## ADDENDUM NUMBER ONE

**A New Agricultural Facility For  
Sullivan County Tennessee  
Blountville, Tennessee**

**February 16, 2016**

**SD-1**

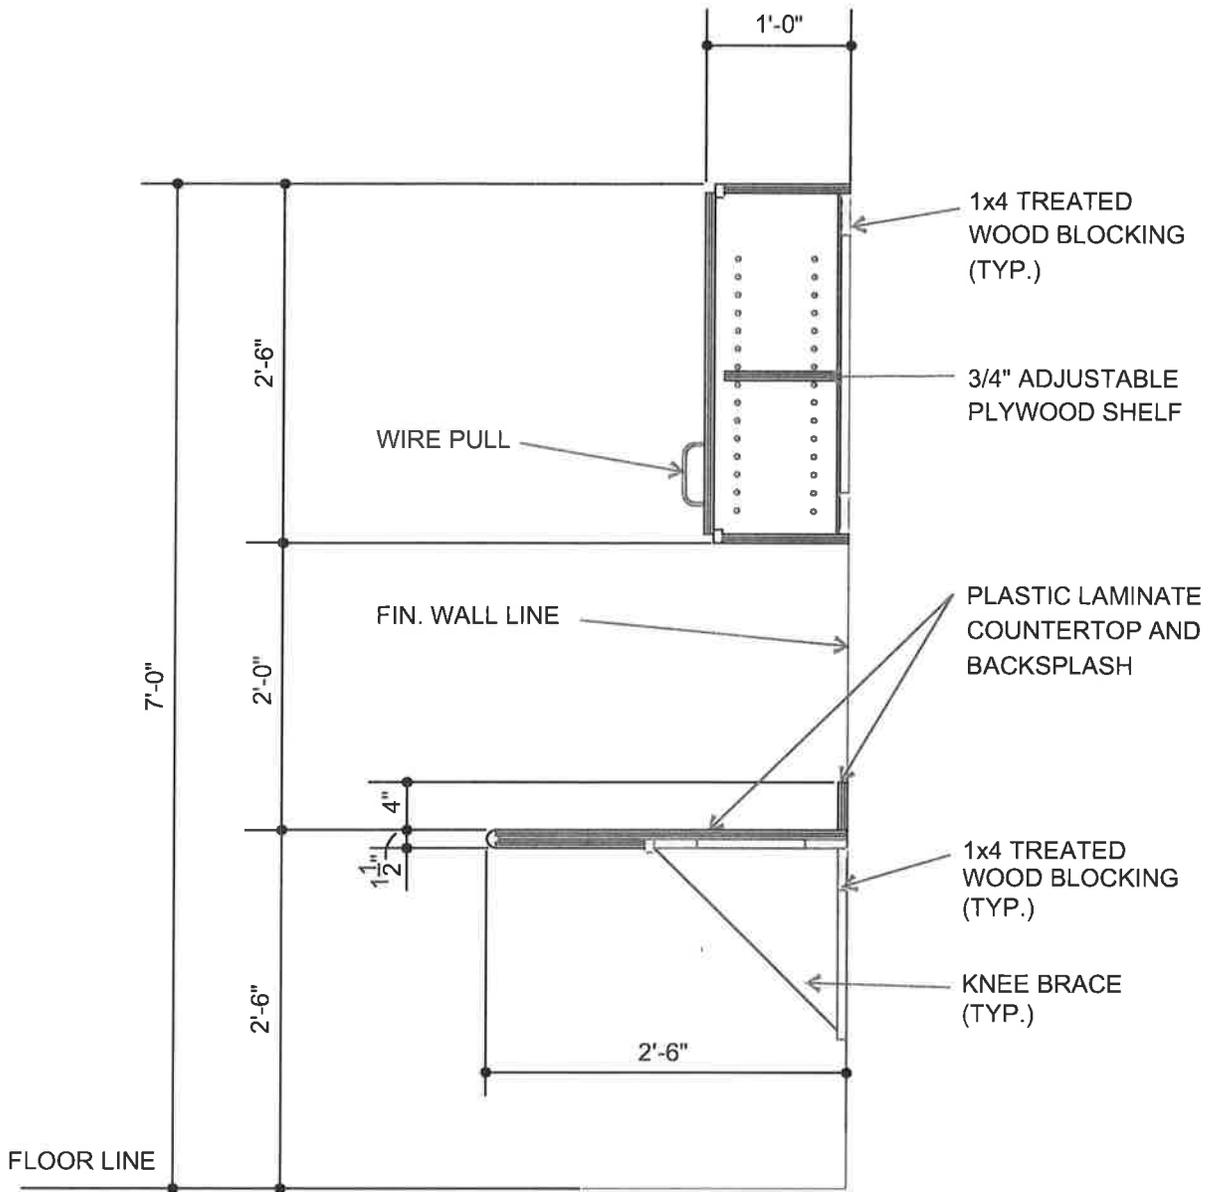
- Elevation L / I-40: Section cut noted as "H / I-41" shall read "C / SD-3". See attached Supplementary Drawing SD-3.
- Elevation P / I-40: Section cut noted as "F / I-41" shall read "A / SD-1". See attached Supplementary Drawing SD-1.
- Elevation P / I-40: Section cut noted as "G / I-41" shall read "B / SD-2". See attached Supplementary Drawing SD-2.

**SD-5**

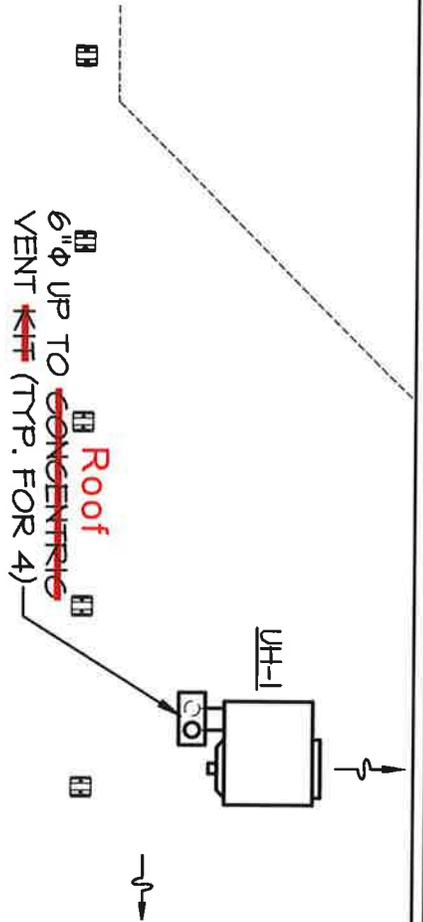
1. PROVIDE MOUNTING HARDWARE.
2. ELECTRONIC IGNITION, PROVIDE 120V SUPPLY WITH 24 VOLT CONTROL TRANSFORMER.
3. ALTERNATIVE MANUFACTURERS: MODINE
4. PROVIDE GAS TRAIN PIPING INCLUDING MANUAL SHUT OFF. GAS CONTROL VALVE PACKAGE, UNION AND DIRT LEG.
5. ~~PROVIDE CONCENTRIC VENT KIT AND VENT IN ACCORDANCE WITH MANUFACTURERS INSTRUCTIONS.~~
6. PROVIDE TYPE B GAS VENT WITH ROOF THIMBLE AND CAP.
7. PROVIDE 2-WAY DISCHARGE LOUVERS.
8. PROVIDE LINE VOLTAGE WALL THERMOSTAT.
